Far West Texas Transmission Project - ERCOT Independent Review

May 16, 2017

Overview

AEPSC and Oncor jointly submitted Far West Texas Project (FWTP) for Regional Planning Group review. The original AEP and Oncor proposal is a Tier 1 project that was estimated to cost \$ 423 million.

Option 1 – Results

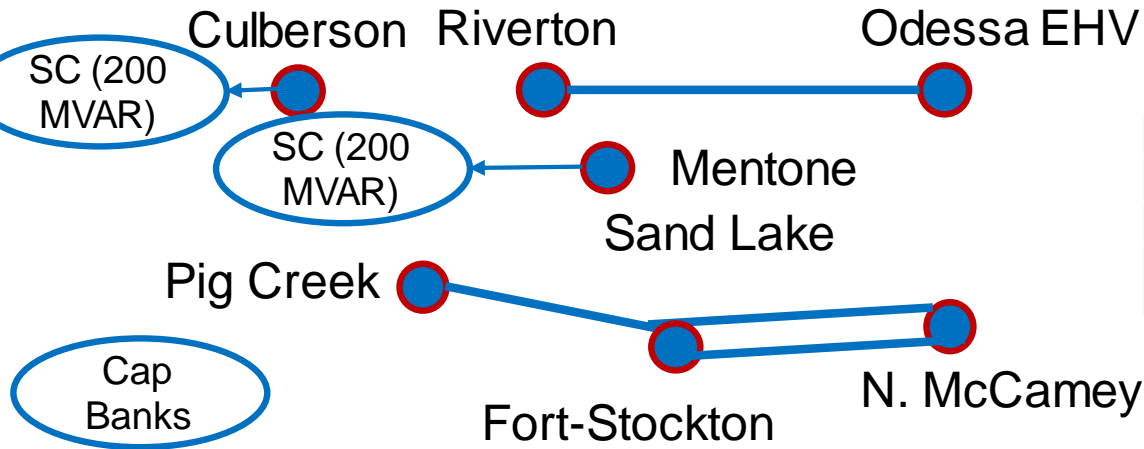
Estimated Cost \$464 Million

Cap bank at Mentone and SaltCreek	36 MVARs each
Cap bank at Orla and Elmar, Loving	18 MVARs each
Cap bank at ALMC	18 MVARs
Cap bank at ESPY, SHAF, TSAND	3.6, 10.8, and 7.2 MVARs

Reliability Assessment	Study Case	Potential Load
PV (Culberson Load)	917 (P6) 927 MW (P7)	
Thermal	Study Case : No Violations No Solar Case : No Violations	Study Case : Violations No Solar Case : Violations
Voltage Violation	Study Case : No Violations No Solar Case : No Violations	Study Case : No Violations No Solar Case : No Violations

Option 2 - Results

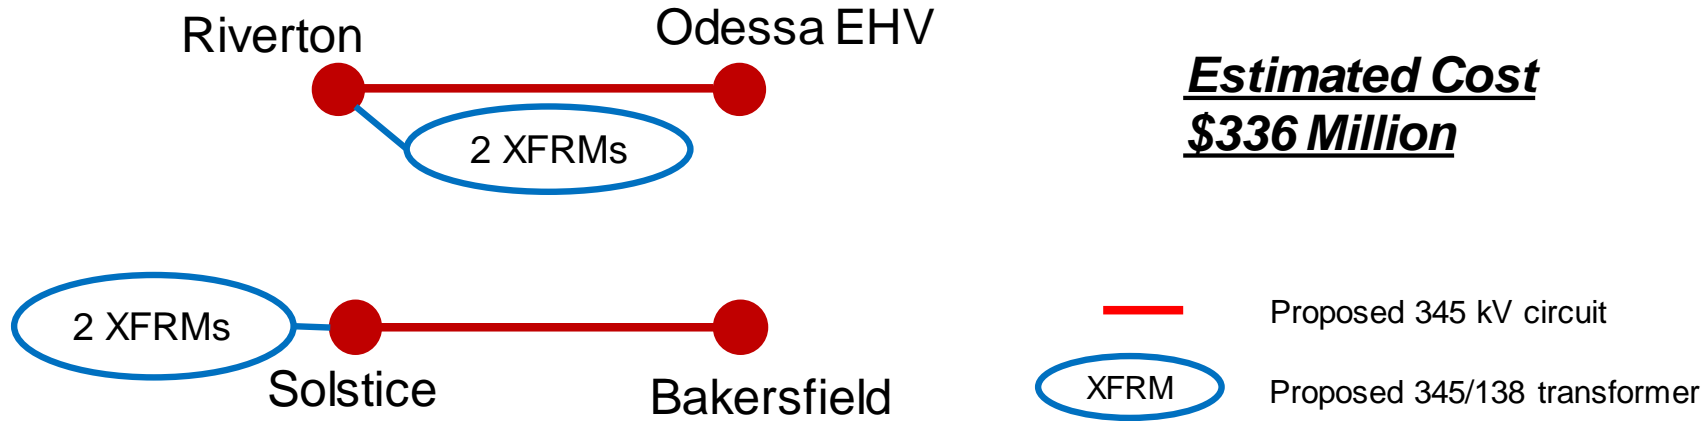
Reliability Assessment	Study Case	Potential Load
PV (Culberson Load)	717 MW (P7) 767 MW (P1, ERCOT X-1+N-1)	
Thermal	Study Case : No Violations No Solar Case : No Violations	Study Case : Violations No Solar Case : Violations
Voltage Violation	Study Case : No Violations No Solar Case : No Violations	Study Case : Violations No Solar Case : Violations

Option 3 - Results

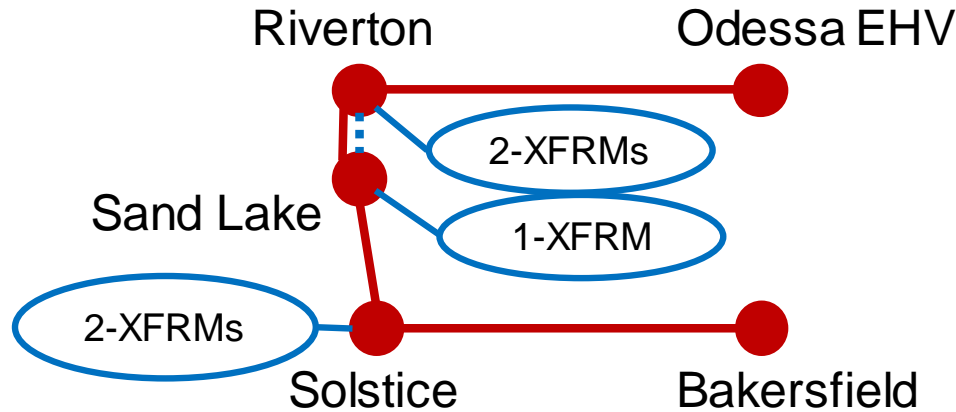
Estimated Cost
\$446 Million

Reliability Assessment	Study Case	Potential Load
PV (Culberson Load)	917 MW (ERCOT X-1+N-1) 967 MW (P7)	
Thermal	Study Case : No Violations No Solar Case: No Violations	Study Case : No Violations No Solar Case: No Violations
Voltage Violation	Study Case : No Violations No Solar Case: No Violations	Study Case : No Violations No Solar Case: No Violations

Option 4 - Results

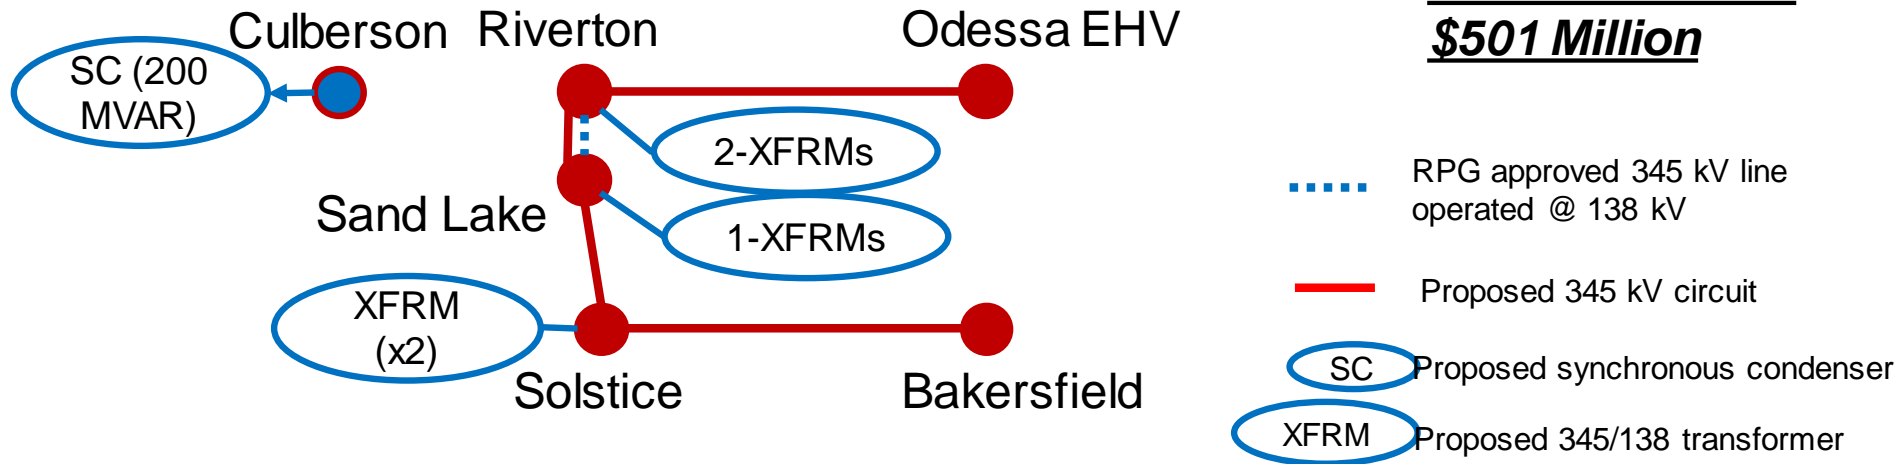
Estimated Cost:
\$501 Million

Reliability Assessment	Study Case	Potential Load
PV (Culberson Load)	1037 MW (P6, ERCOT X-1+N-1) 1137 MW (P7)	
Thermal	Study Case : No Violations No Solar Case: No Violations	Study Case : No Violations No Solar Case: No Violations
Voltage Violation	Study Case : No Violations No Solar Case: No Violations	Study Case : No Violations No Solar Case: No Violations

ERCOT Recommendation – Option 2

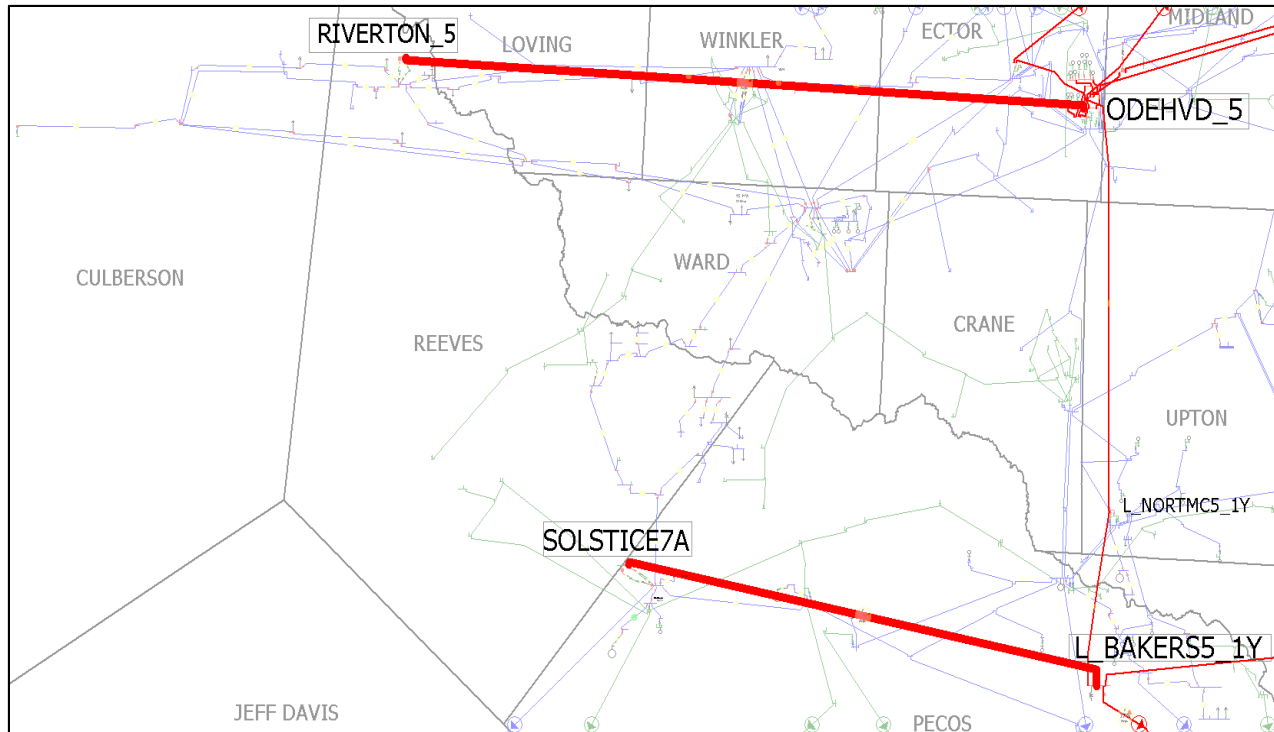
- Based on the review, ERCOT will recommend the Board endorse Option 2 to address the reliability need in the study region:
 - Expand the Riverton Sw. Sta. to install a 345 kV ring-bus arrangement with two 600 MVA, 345/138 kV autotransformer

- Construct a new approximately 85-mile 345 kV line on double-circuit structures with one circuit in place, between Moss and Riverton Sw. Sta. Add a second circuit to the existing 16-mile Moss Sw. Sta. – Odessa EHV 345 kV double-circuit structures. Install 345 kV circuit breaker(s) at Odessa EHV. Connect the new circuit from Riverton Sw. Sta. and terminate at Odessa EHV to create the new Odessa EHV – Moss - Riverton 345 kV Line

- Expand the Solstice Sw. Sta. to install a 345 kV ring-bus arrangement with two 600 MVA, 345/138 kV autotransformer
 - Construct a new approximately 68-mile 345 kV line from Solstice Sw. Sta. to Bakersfield station on double-circuit structures with one circuit in place

- Estimated Capital Cost: \$336 million
